**New Plymouth
District Council**

NOTIFICATION REPORT ON AN APPLICATION FOR A RESOURCE CONSENT AND CANCELLATION OF A CONSENT NOTICE

Application Number:	LUC25/48839 & SUB17/46785.02
Proposal:	Construction of a Bunnings Warehouse
Applicant:	Bunnings Limited
Site Address:	662 Devon Road, New Plymouth
Legal Description:	Lot 1 DP 509004 (RT 775834) and Lot 4 DP 509004 (RT 837990).
Owner(s):	Bunnings Limited
Zone:	General Industrial Zone
DP Overlays:	Volcanic Hazard Area, Site of Significance to Māori, Entrance Corridor, Nise Control Boundary, Waterbody Stormwater Flooding Area (Non District Plan layer). Rail Corridor Vibration Alert Area, Rail Corridor Noise Alert Area (information only)
Date Application Received:	29 July 2025
Activity Status:	Discretionary

Figure 1: Existing Consented Development (on Left) and Proposal (on Right)

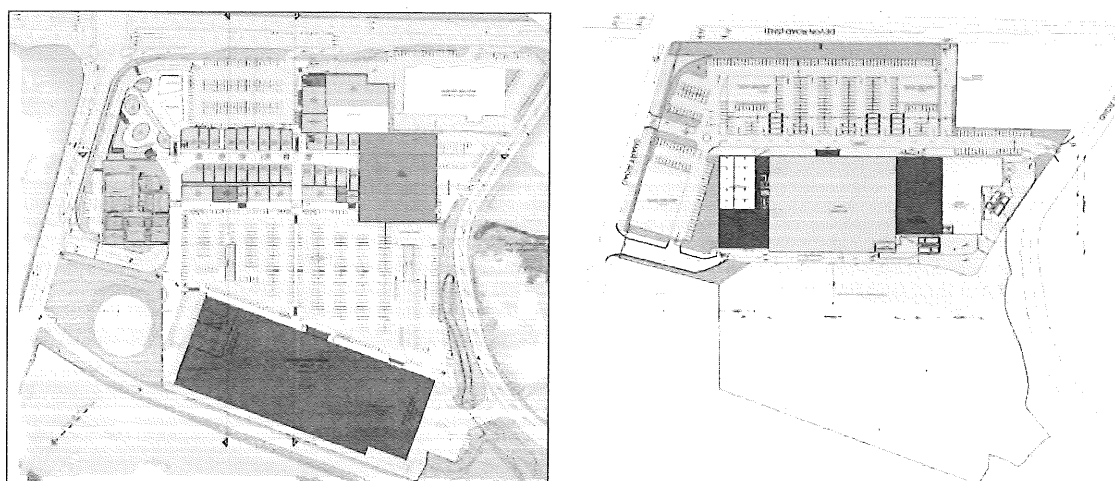
The TAR discusses future changes to the land use and transport networks, and noting that consents have been granted for a large shopping complex with some 34,100sqm and generating around 1,000 vehicles in the weekday evening peak hour. We understand that this site is the same as the application site, and that the Bunnings proposal replaces this. However it is not clear whether the existing consent is fully or only partially replaced:

Consequently it is unclear whether any parts of the remainder of the site form part of the receiving environment for the Bunnings application.

Figure 2: 20m B-Train Exiting Site

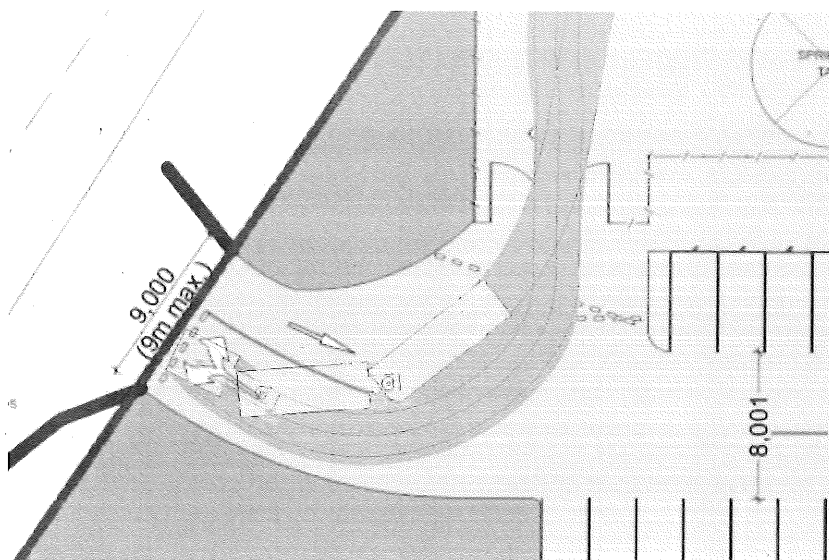
We also highlight that the TAR sets out that 20m of queuing space is provided at each proposed access. However, the queuing space at Access 3 (Katere Road) will be substantially limited if a large vehicle exits the loading bay and turns left to exit the site. The TAR notes that the store will

be serviced by 23m B-trains and in the Figure below we show a 20m B-train exiting. This indicates that the queuing space will be reduced to around 8m.

In our experience, a scenario where larger delivery vehicles affect customer vehicle movements is not uncommon and can be addressed through conditions of consent relating to times of servicing. We recommend that the same approach is taken in this case (or a further assessment of effects is provided to show that the potential for queuing of two incoming vehicles is minimal).

Figure 3: Change in Traffic Flows Due to Proposed Development in the Weekday Peak Hour

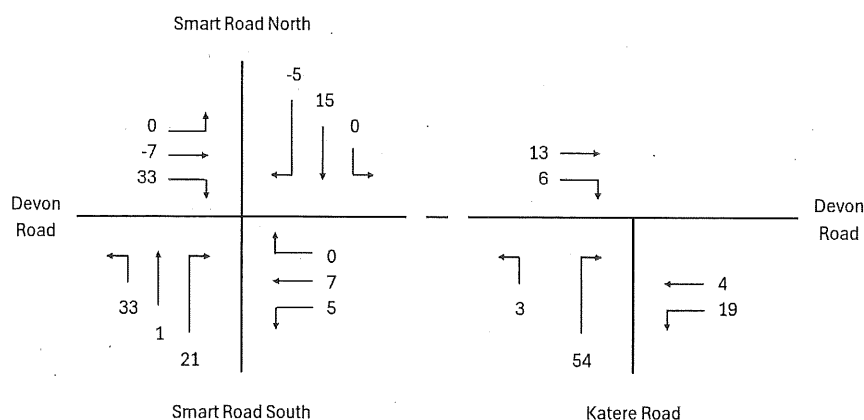
Negative numbers are not unreasonable in this context as they indicate pass-by traffic diverting to a different route. However in some cases these volumes do not reflect the assumptions set out in the TAR. From the direction of travel, it is possible to determine in most cases to determine whether the vehicle has exited the site or is entering. For example, the movement from Smart Road North must be an entry movement and the left turn from Smart Road South must be an exit movement. We have highlighted exit movements below:

Figure 4: Exit Movements from the Site in the Weekday Peak Hour

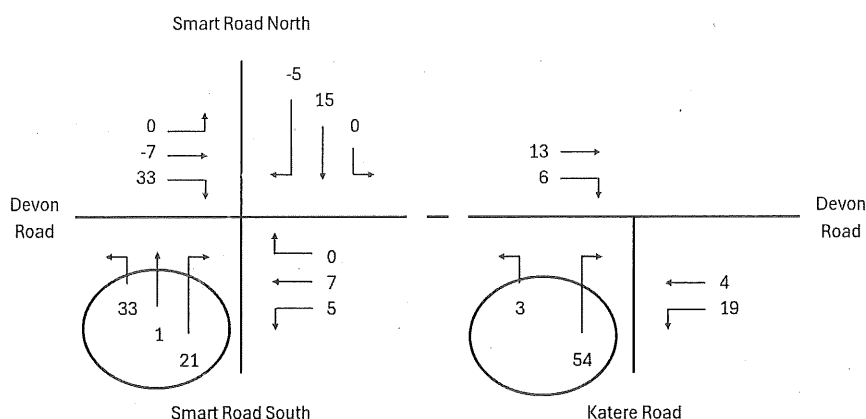
This indicates that of the expected total of 176 vehicle movements, 112 (64%) are vehicles exiting the site. This does not align with the figure of 89 vehicles of Table 7-4.

Figure 5: Entry Movements from the Site in the Weekday Peak Hour

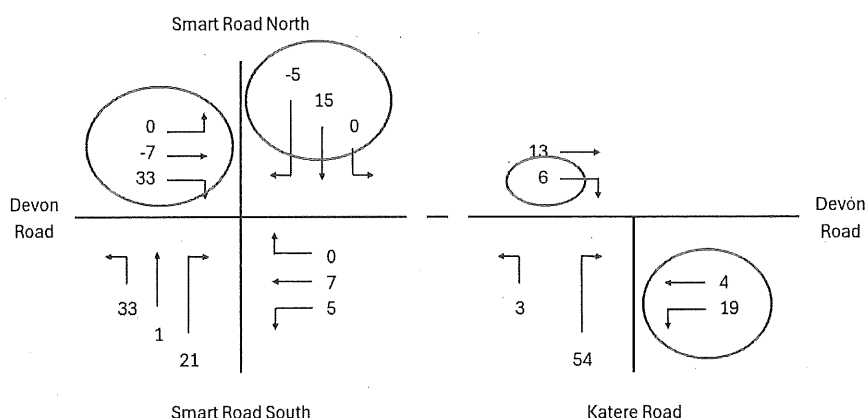
This shows that 65 movements are entry movements, or 36% of the total, which again does not reflect the 87 vehicle movements of Table 7-4. However the total number of movements (entry+exit) however does correspond for both the TAR and the modelling.

Figure 6: Design Issues with Some Parking Spaces

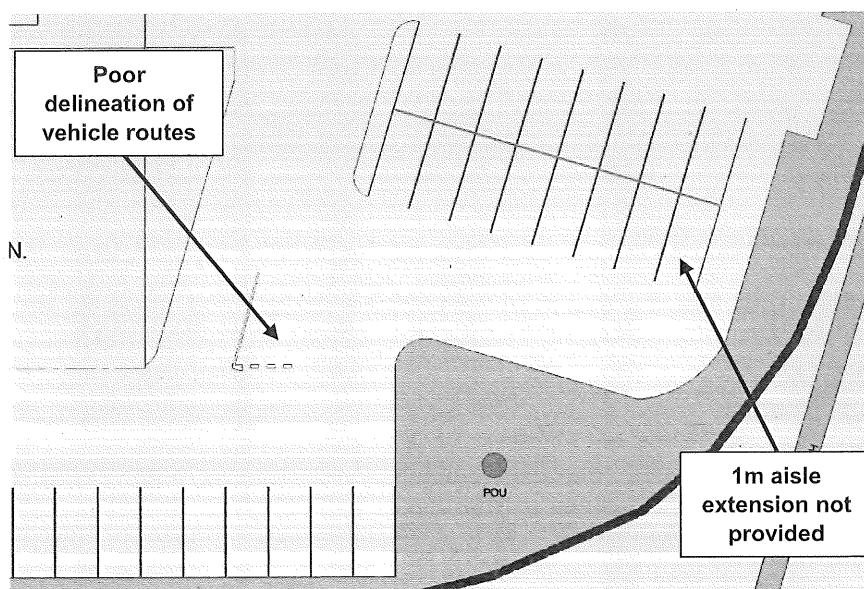
One space does not have the expected 1m aisle extension and we also highlight that this area provides poor delineation of approach routes for several spaces:

This location is in the furthest location from the building, and so is likely to be the least well-used. Consequently we consider that the layout can be supported. However if traffic volumes were to increase, such as would occur if Pad Site 2 was developed, then this mitigation would not be present. We recommend that this part of the design is reviewed again at the time a resource consent application for Pad Site 2 is made.
